Eastern Gas Pipeline Modification 2

Transfer of Port Kembla Gas Terminal Pipeline Segment
and Addition of Cringila Lateral Pipeline
State Significant Infrastructure Modification Assessment
(SSI 9973 MOD 2)

Published by the NSW Department of Planning and Environment

Figure 4 | Location specific individual risk contours – Port Kembla Lateral Looping Pipeline (Source: Worley (2021) Port Kembla Gas Terminal to Eastern Gas Pipeline – Final Hazard Analysis)

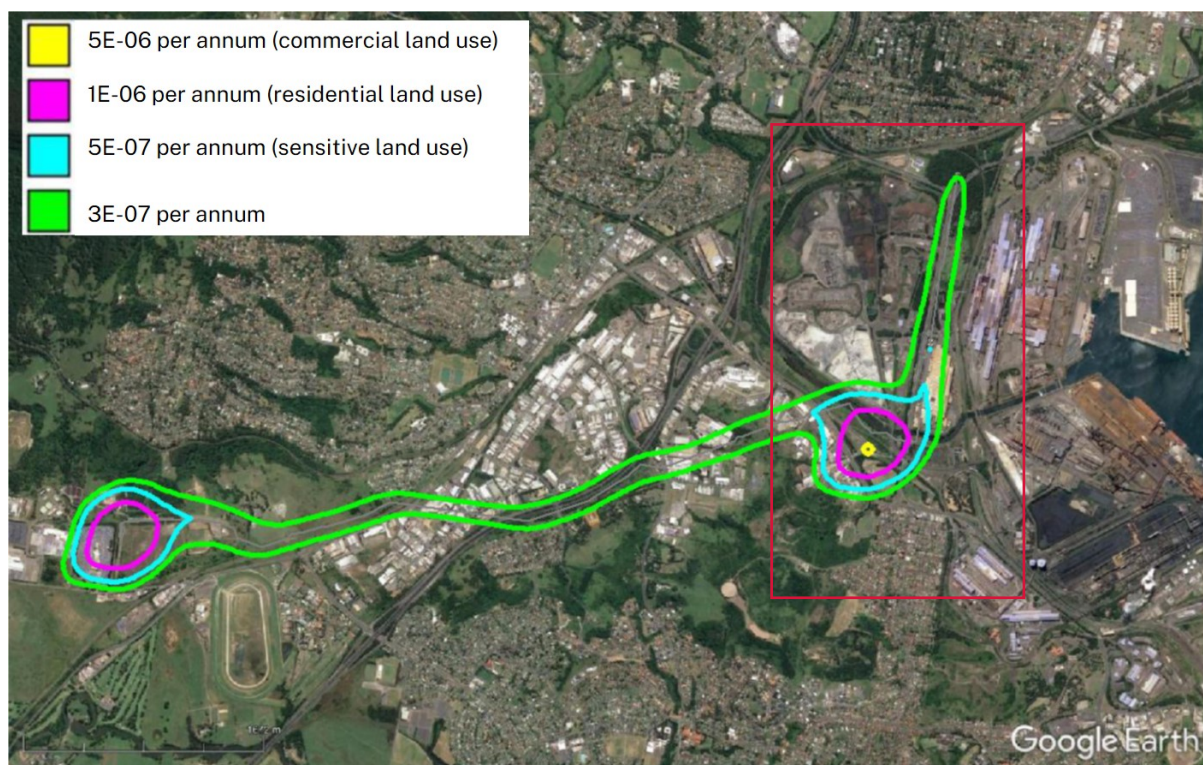
Figures 4 and 5 below illustrate location-specific individual risk contours for the proposed pipelines and the Port Kembla Lateral Looping Pipeline. The model indicated that the risk exposure for the proposed modification would be below the fatality risk criteria in **Table 3** for the relevant land uses. No

sensitive land uses occur within the areas with a fatality risk greater than the HIPAP 4 criterion of 5E-07 per annum.

Figures 4 and 5 include a risk contour for 3E-07 per annum to demonstrate the model output and predicted risk level along the length of the proposed pipelines. A risk criterion of 3E-07 is below all HIPAP 4 criteria outlined in **Table 3**.

Figure 5 | Location specific individual risk contours – Cringila nitrogen facility and lateral pipeline (Source: Worley (2021) Port Kembla Gas Terminal to Eastern Gas Pipeline – Final Hazard Analysis)

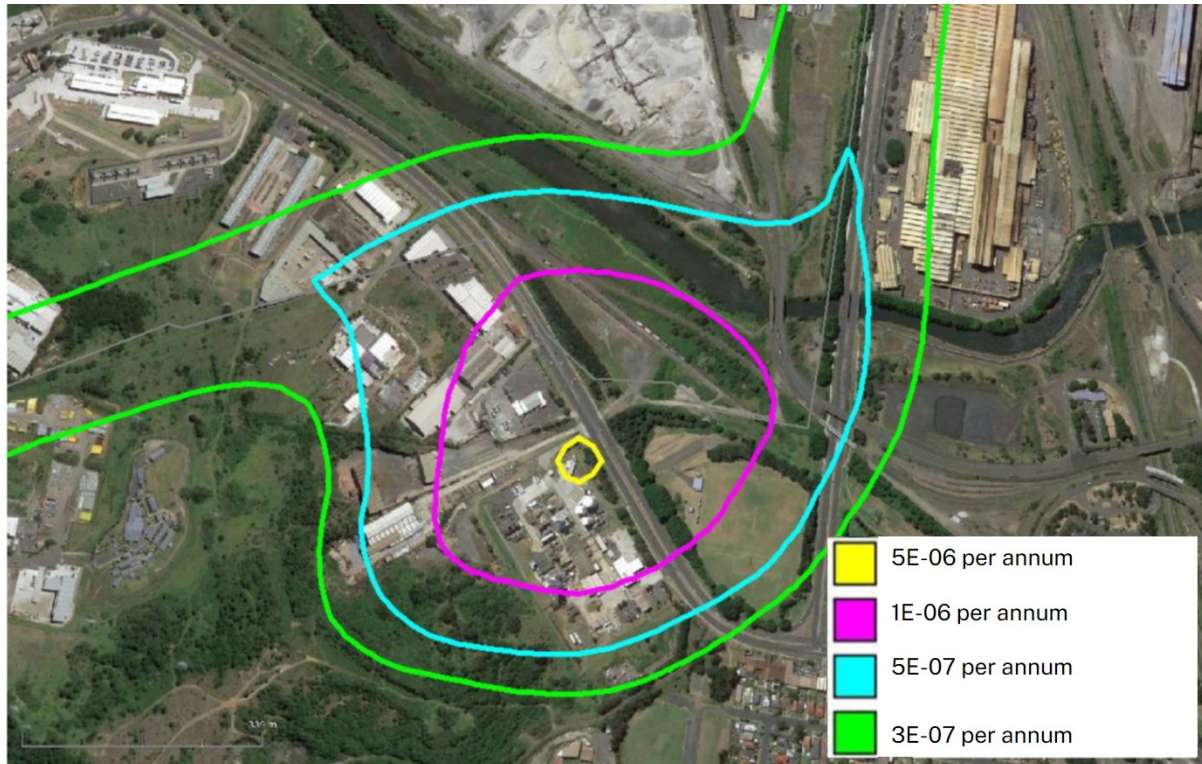
The hazard assessment used a conservative approach by considering the Cringila Lateral tie-in infrastructure as potentially containing flammable gas (up to the BOC tie in point). The higher probability of ignition model produced a slightly higher risk for the Cringila Lateral tie-in infrastructure, with a localised area showing more than a 5E-06 per annum risk level (refer to **Figure 5**). However, the land within this contour is used for industrial purposes and the level of risk complies with the HIPAP 4 criterion for industrial land uses.
